Date: July 25, 2024
To: Prospective Firms
From: City of Cleveland, Department of Port Control
Subject: Addendum No. 3 to Request for Proposal – Tenant Temporary Structure Design/Build Services

Please be advised that the City of Cleveland, through its Director of the Department of Port Control (“Department”), hereby publishes Addendum No. 1 to the Request for Proposal – Tenant Temporary Structure Design/Build Services, dated July 5, 2024.

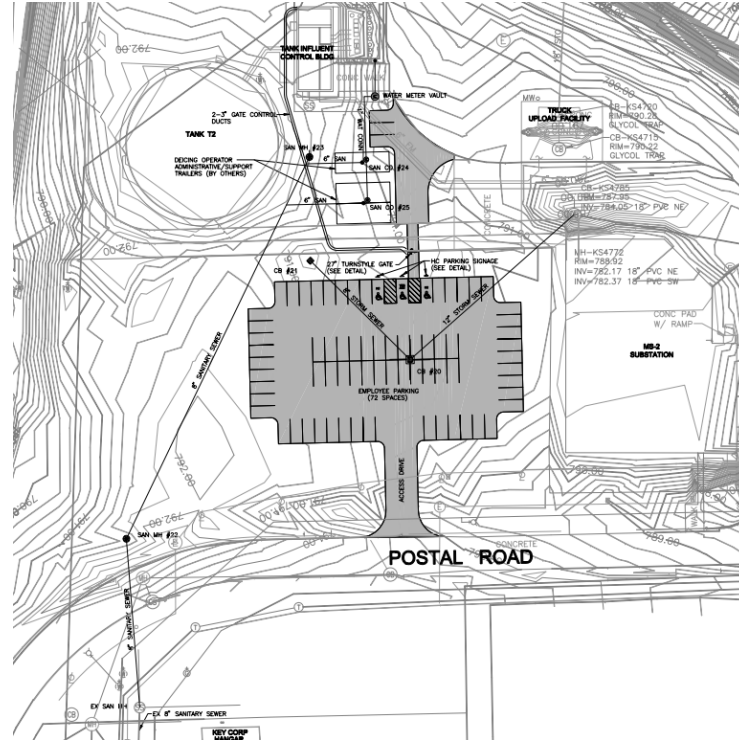
Building MS -2 is no longer an option as an available power source. The updated site to extract external power is now the glycol tank area. The following information on the projected area and specifications are listed below:

1.	Question	What is the voltage and phase of the closest power source? What is the manufacturer and what is the space capacity in the panel? Is a separate consumption meter required?
	Answer	The distribution transformer outside of the glycol tanks is now the closest available power source. 480V three phase can be tapped to a disconnect that the contractor will need to install. 200 amps could be

available at 480V. There is also a 120/208-volt panel that is closer with a 100-amp spare that can possibly be used if capacity is determined to be insufficient.

See diagram location and photos below:

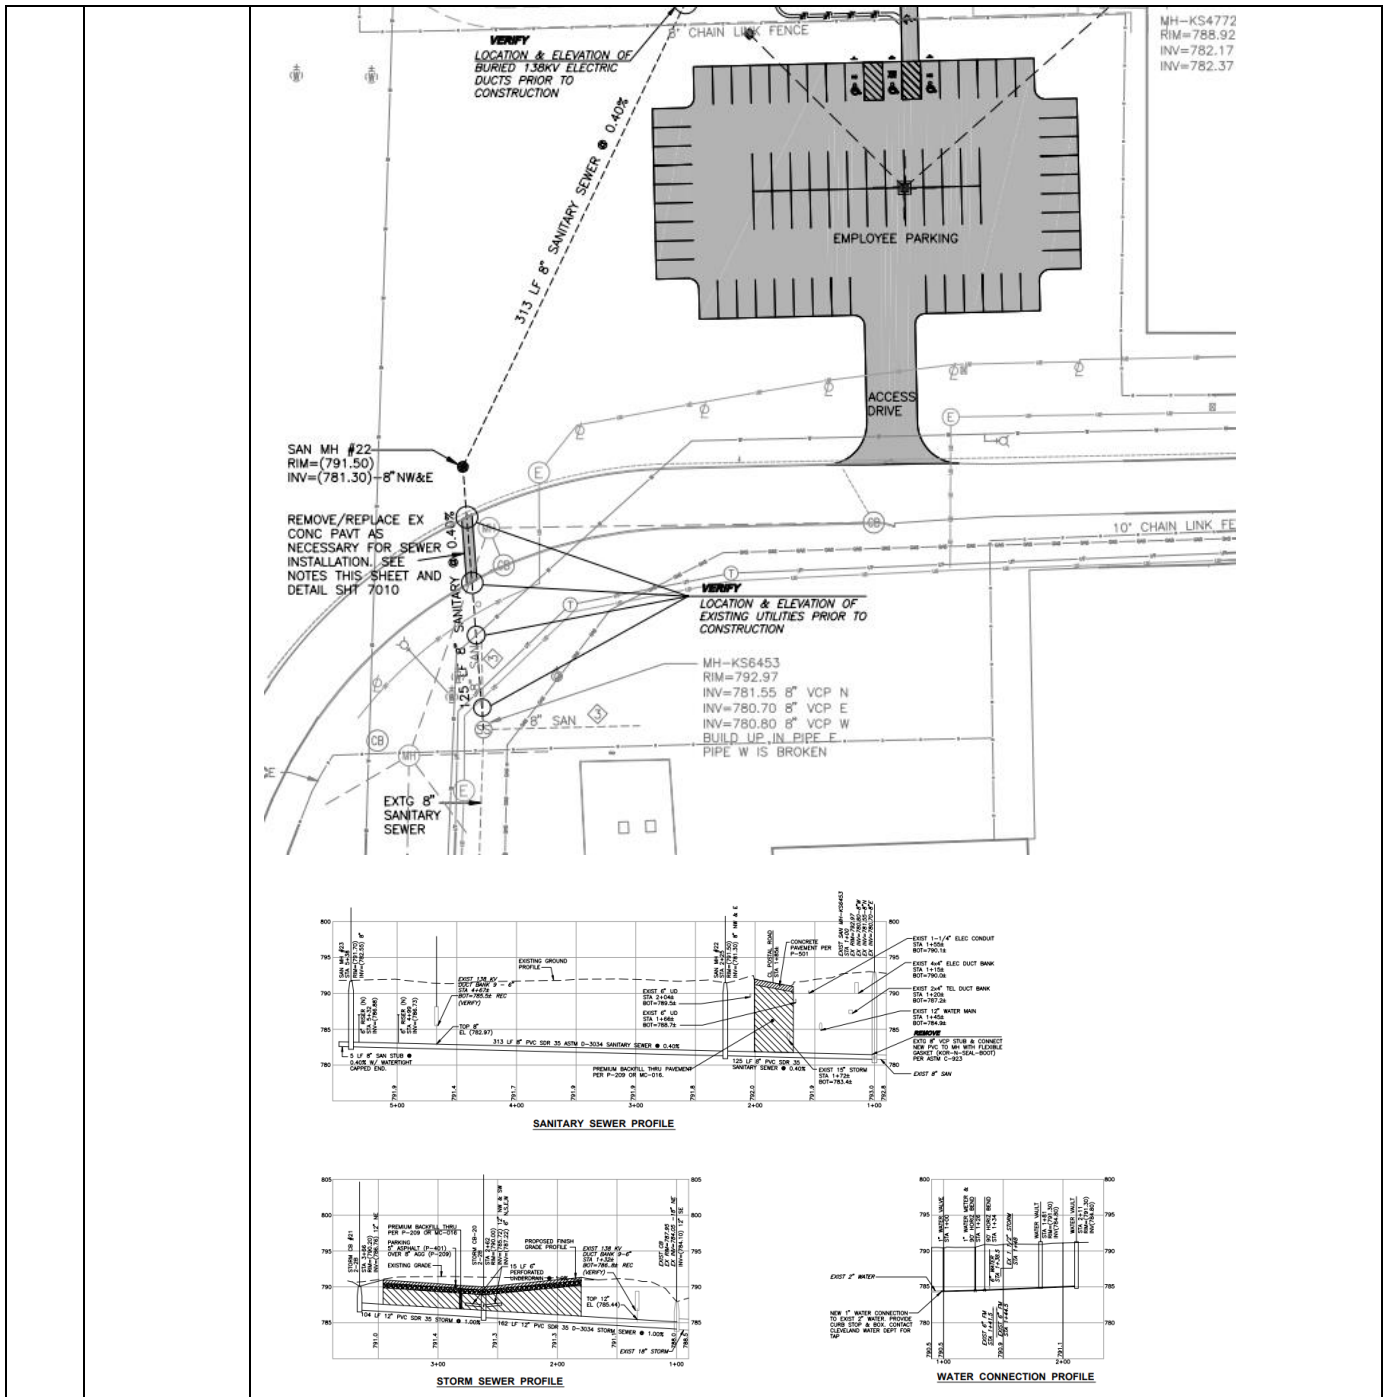
18.	Question	Per RFP section 2.2.B.6, please advise if the cost of the generator should be included in the fee proposal, or whether the intent to provide only the infrastructure for a roll-up generator by others.

Answer	The tenant is responsible for their own generator, have wiring in place for connection.
19.	Question	Per RFP section 2.2.A, can additional instructions be provided for the above-grade containment system?

Answer	The intent of the “above-grade containment system” is to prevent materials/contamination (such as oils, greases, aircraft deicers – propylene glycol, detergents, snow melt, etc.) from entering the storm sewer system by having the building act as secondary containment or other similar means. The design-build team is expected to address these concerns in their design.
